APPEAL SUMMARY

Appeal ID: 22155

Building/Business Name: Parkview at Terwilliger Plaza

APPEAL INFORMATION SHEET

Appeal 01 Item 06 Exhibit A

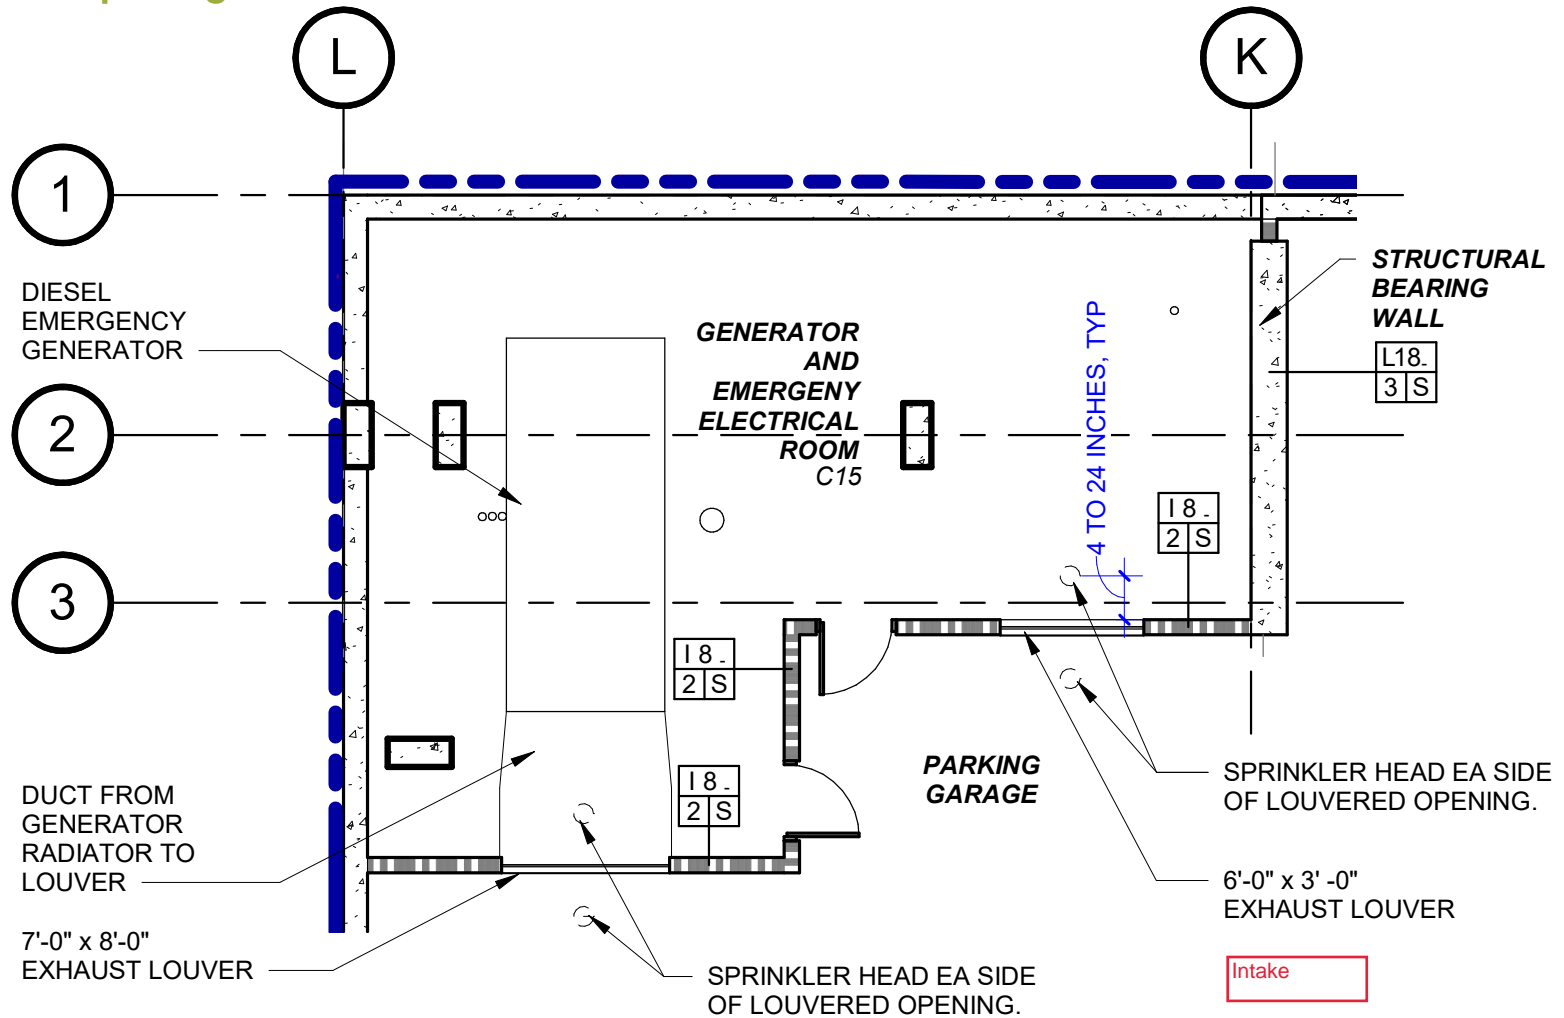
Code Section	City Code Guide IBC/27/#1, City Code Guide NEC/7/#1, OSSC 716.5 Opening Fire Protection Assemblies, Ratings and Markings
Requires	<p>City Code Guide IBC/27/#1 & NEC/7/#1: Where an emergency power generator is installed inside a building, the equipment shall be located in an enclosure capable of providing a two-hour occupancy separation from all other occupancies and uses, including mechanical equipment.</p> <p>Table 716.5: Openings in fire barriers having a fire resistance rating of 2 hours are required to be protected by a fire door or fire shutter assembly with a minimum 1-1/2-hour fire rating.</p>
Proposed Design	<p>The generator is located in the northwest corner of the P2 level parking garage in an enclosure separating the generator from adjacent occupancies by a two-hour separation. The generator provides emergency power to the egress lighting throughout the building, powers the egress occupant evacuation elevator and powers the elevator shaft pressurization mechanical unit. Air intake and exhaust openings for make-up/combustion air and ventilation of waste heat from the radiator are required for operation of the generator. Fire-smoke dampers, required by OSSC Table 716.5, would prevent combustion air from entering the generator enclosure thus disabling the generator.</p> <p>The proposed design is to bring clean/cool air from the garage into the generator enclosure through a 6' x 3' louvered opening on the southeast side of the enclosure. This air will provide the required combustion and radiator cooling air for the generator.</p> <p>Air from the generator radiator exhaust will discharge directly into the parking garage at the southwest side of the enclosure through a 7' x 8' louvered opening. There will be a duct from the radiator to the louvered opening in the wall of the enclosure. A dedicated fire sprinkler head on each side of the two louvered openings, located between 4 and 24 inches from the opening, will be provided.</p> <p>Please see the attached exhibits.</p>

Reason for alternative	<p>The emergency generator provides power to life-safety devices and emergency egress lighting. Because the cooling and combustion airflow is required for generator operation, it is critical that there are no devices in the intake or discharge air path which could restrict or prevent airflow. Because a mechanical fire/smoke damper would prevent airflow, we have proposed the alternative solution for garage transfer air intake and exhaust above.</p> <p>The enhanced sprinkler coverage provides continuity of the fire rated occupancy separation. We feel the above method will provide an equivalent level of protection to fire dampers while allowing the emergency power generator to function as required in the event it is necessary.</p>

6a. Emergency generator with intake air from within parking garage and exhaust air discharge into parking garage: Denied. Proposal does not provide equivalent Life Safety protection.

6b. Emergency generator with intake and exhaust louvers in two hour enclosure with sprinkler head on each side in lieu of fire damper: Denied. Proposal does not provide equivalent Life Safety protection.

Appeal 01 Item 10 Exhibit A

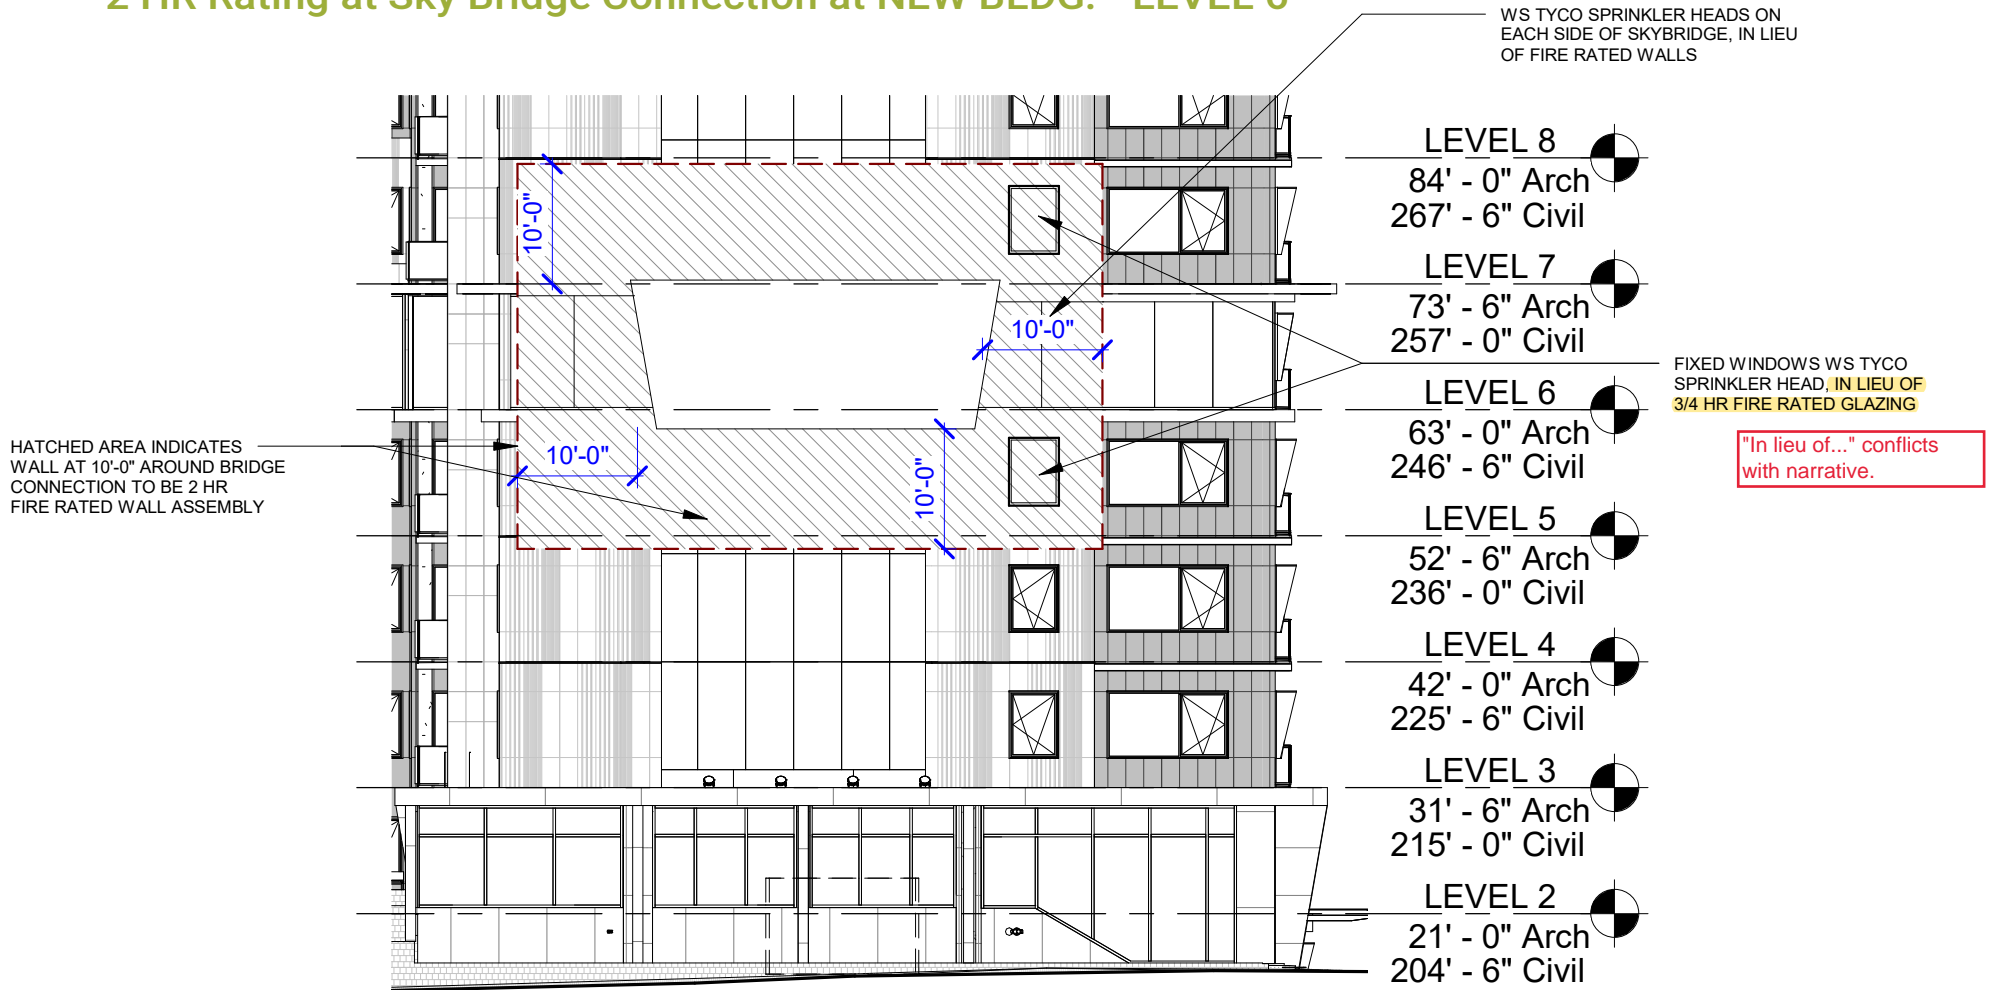
The proposed new building is a 9-story Type I-A building that has a pedestrian walkway at the 6th Floor. This pedestrian walkway is located approximately 60 feet over a public right-of-way to an existing building on the adjacent block to the west. Both buildings will be owned and operated as a single senior living facility.

The pedestrian walkway will be separated from the interior of the building by a 2-hour rated wall with 90 minute rated doors. All exterior wall assemblies within 10 feet of the pedestrian walkway will also be 2-hour rated.

The proposed design for the new building has windows located within 10 feet of the pedestrian walkway. There are two bathroom windows, one located on the story above (7th Floor) and one located on the story below (5th Floor). These two windows will be fixed and 45 minute fire rated per §3104.5.

There are also full height tempered glass windows within 10 feet of the pedestrian walkway. These windows will be provided with Tyco Model WS sprinklers on each side of the window per ICC ESR-2397 to provide equivalency to a 2-hour fire-resistance rating, which exceeds the requirement for 45 minute fire rated opening protection.

Therefore, it is requested that glazing protected by Tyco sprinklers on both sides installed in accordance with ICC ESR-2397 be accepted within 10 feet of the pedestrian walkway.

10. Pedestrian walkway with glazing within 10 feet and 2 hour protection provided by Tyco WS sprinklers: Granted provided Tyco WS sprinklers installed in accordance to ICC ESR-2397.
